VALLEJO CENTER

NEW CLASSROOM BUILDING

DSA APPROVAL SET
DECEMBER 8, 20005

AS BUILTS

1 PARTIAL ROOF PLAN
SCALE 1/8" = 1'-0"

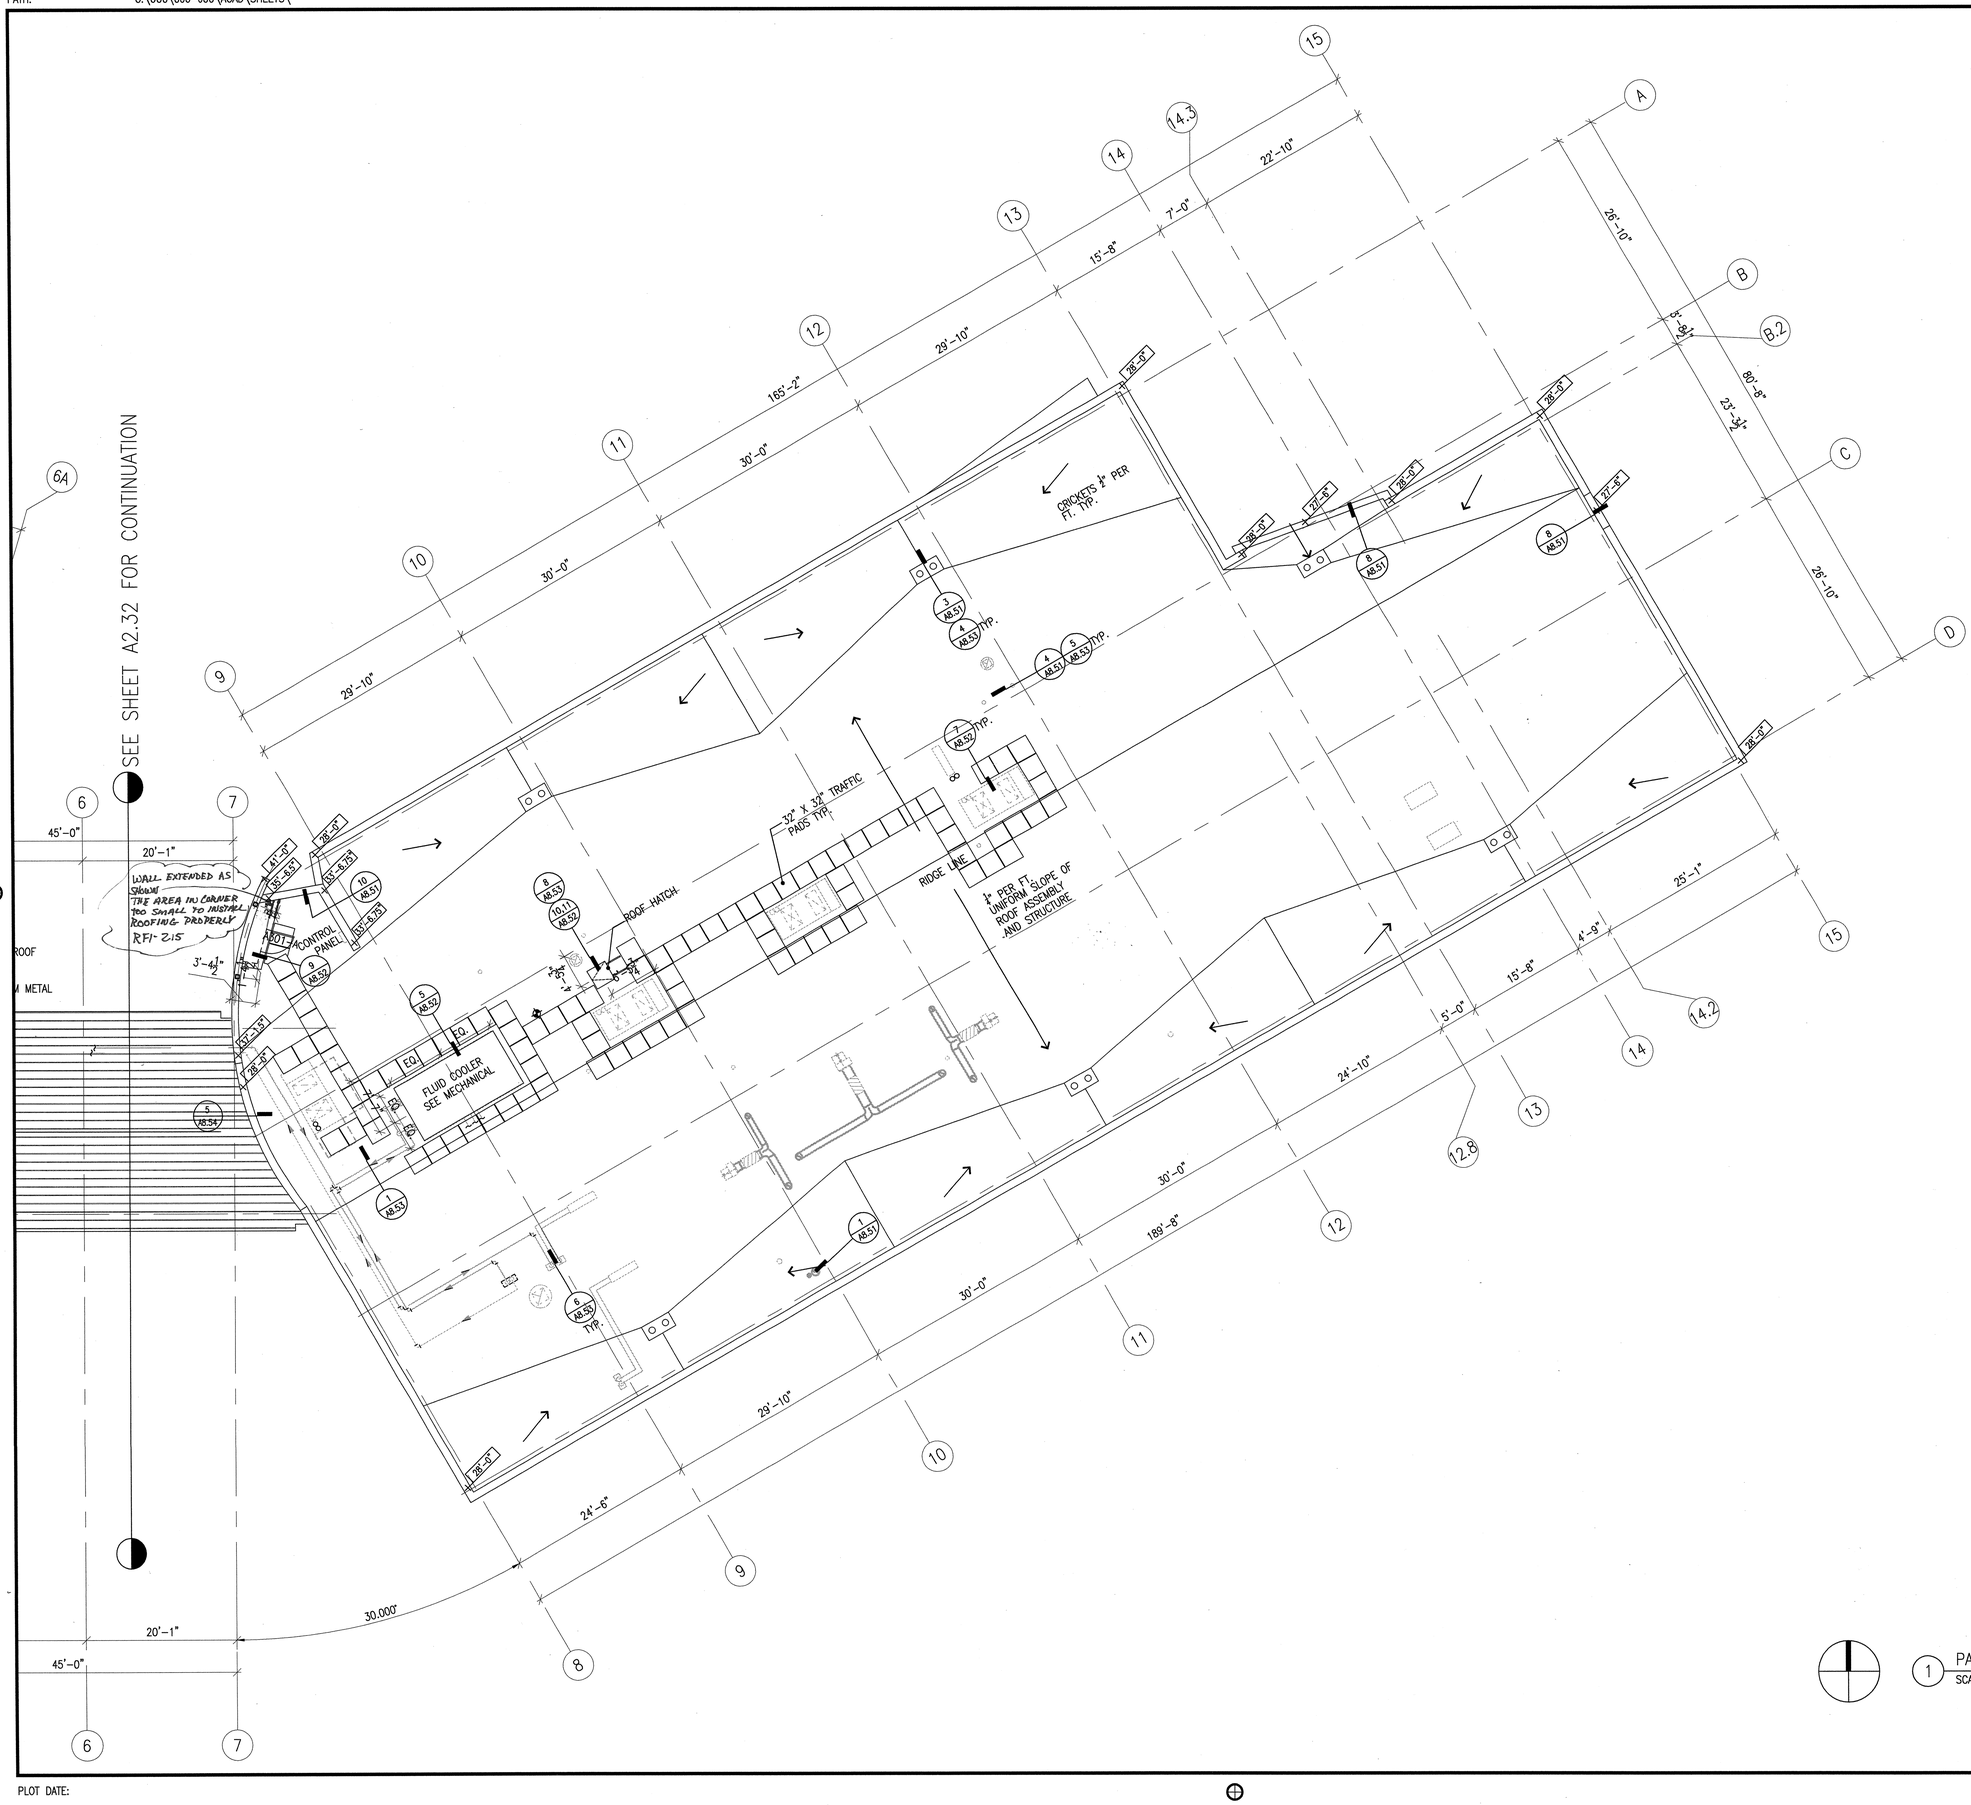
Question
Date Required: 12/19/2005
Review attached sketches modified from Contract drawings A2.31 and 1/A8.03. The space between the NORTH end of window #1 and the adjacent parapet wall just to the NORTH will not provide the minimum 12"clearance required between vertical turn-up of roofing. The NORTH wall of the window access structure (1/A8.51) can not be constructed 6 inches from the center of the vertical roofing membrane at the NORTH end of window #1 and still provide the minimum 12" clearance standard requires 12 inch clearance. This standard spacing is shown in detail 12/A8.52. We would not be able to issue a roofing manufacturer's 10 year warranty unless the minimum 12 inches is achieved. The attached MODIFIED copies of sheets A2.31 and 1/A8.03 show the proposed solution. The NORTH wall of the access structure will have the 12 inches of clear space between vertical turn-up of roofing materials. We had constructed the parapet wall at the NORTH end of stair #1 before we realized that this conflict existed. This NORTH (of Stair #1) parapet must be removed and reconstructed 6 inches to the NORTH in order to allow the exterior parapet cap coping to become the counter flashing to the sloped metal roofing. To raise the NORTH parapet at Stair #1, we intend to sever metal studs beside the vertical studs a minimum of 24 inches and screw Simpson strong tie A35 clips to the studs with #10 screws at 8" O.C. acceptable to the Structural engineer?

1 DETAIL FLOOR PLAN
SCALE 1/4" = 1'-0"

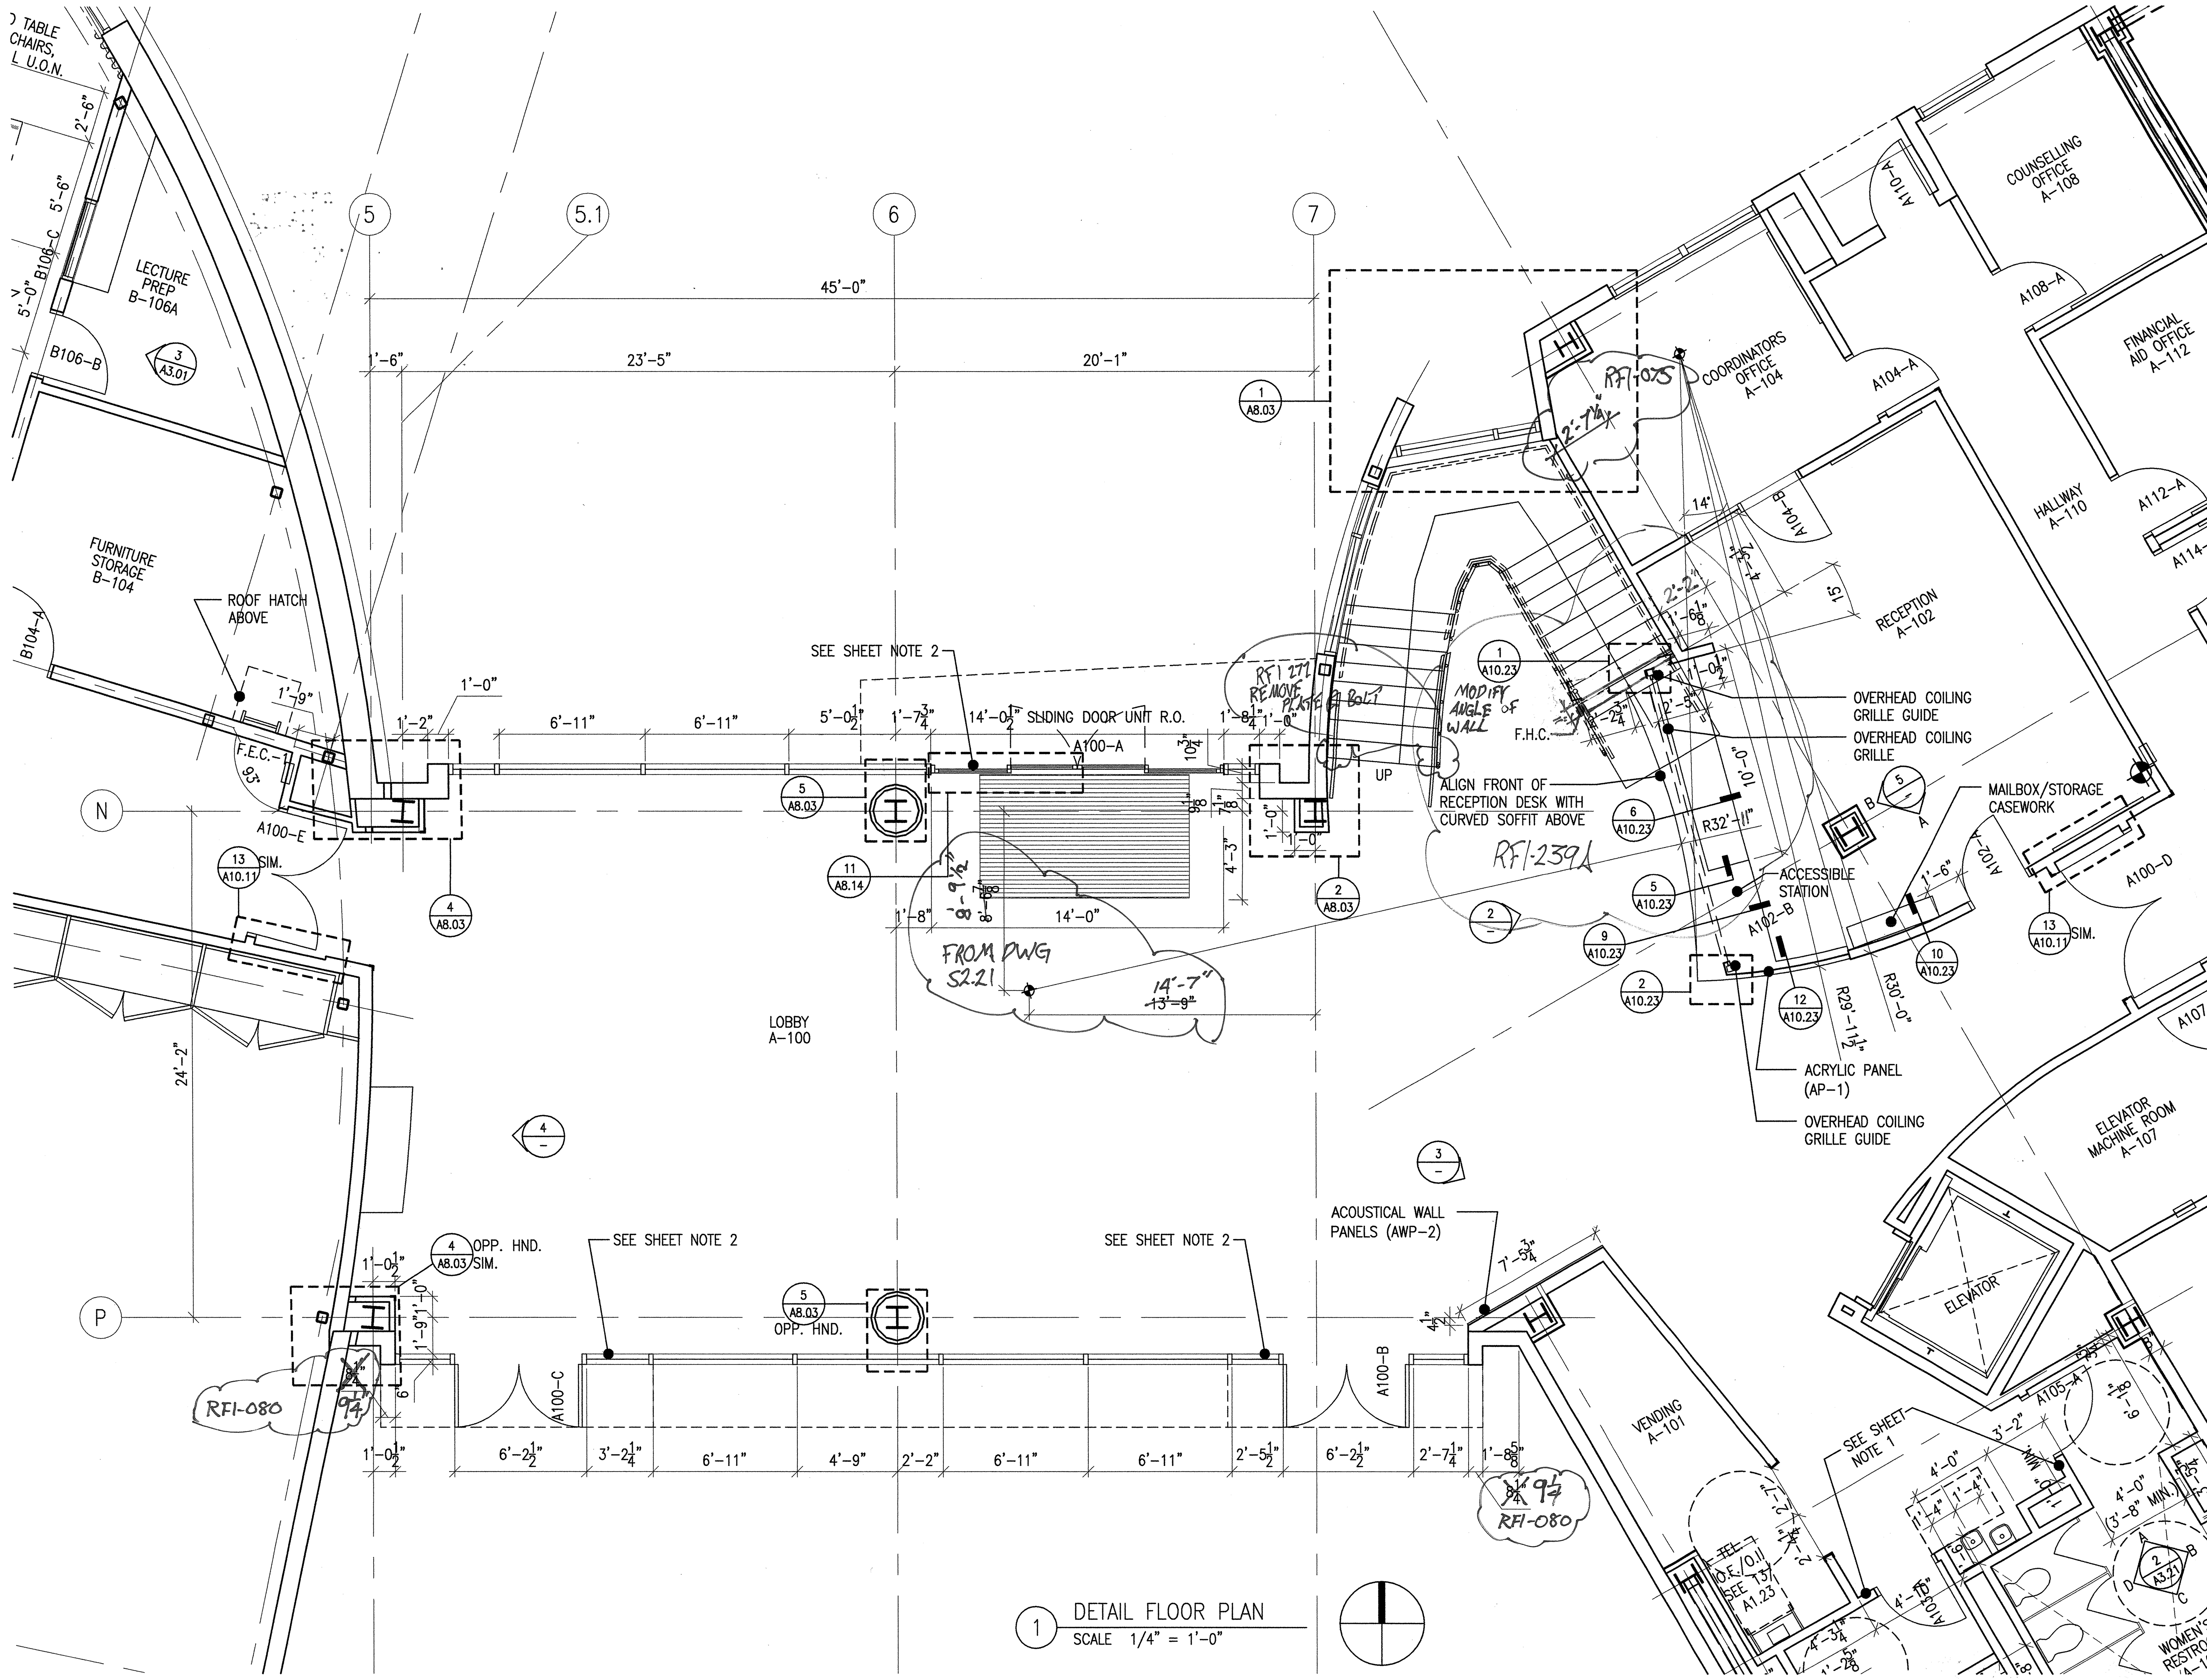
Question
Coordination of the radius center points has not resolved all the conflicts at the reception counter, walls and soffit framing. I have set some photographs (by email) to Matt Youdall that shows the conflicts. Please discuss this RFI-239A with Mr. Youdall. Review the attached sketches showing CHANGES to the Contract Drawings needed to resolve the conflicts. The structural support beam and bracket (shown in detail 15a/S7.05) protrudes beyond the finish soffit. Look at detail 7/A7.03 the detail shows installing one 7/8" furring channel on the bent plate and then applying one layer of gypsum board. We could extend the vertical soffit framing (beyond the bent plate) by about 4 inches (versus the 1½" shown) if we allow the vertical stud framing to be installed outside of the bent plate. This change in framing would reduce the finish radius dimension and allow the vertical gypsum board to conceal the steel beam and bracket that supports the (tube steel) stair stringer.

The wall framing at the North end of the reception desk is shown a an angle that is not parallel with the stair risers. If the North wall at the reception desk is constructed where shown the stair risers at the South side of the wall are lower than the 10'- 6" soffit height required by detail 7/A7.03. The bottom of the lowest stair tread is about 9'- 5" near the West end of this (north end of reception counter) wall. If we change the angle for the North wall (at the reception counter) we could align this wall with the stair tread and achieve a bottom of stair tread of about 10'- 0" AFF on the South side of this wall. By aligning the (North) wall at the reception counter with the stair treads we could achieve a bottom of finish soffit elevation of about 9'- 10½" versus the 10'- 6" shown in 7/A7.03). Mr. Youdall want the North end of (vertical face of) the soffit to be straight and located under the (tube steel) stair stringer until the soffit ends at the North wall of the Reception counter.
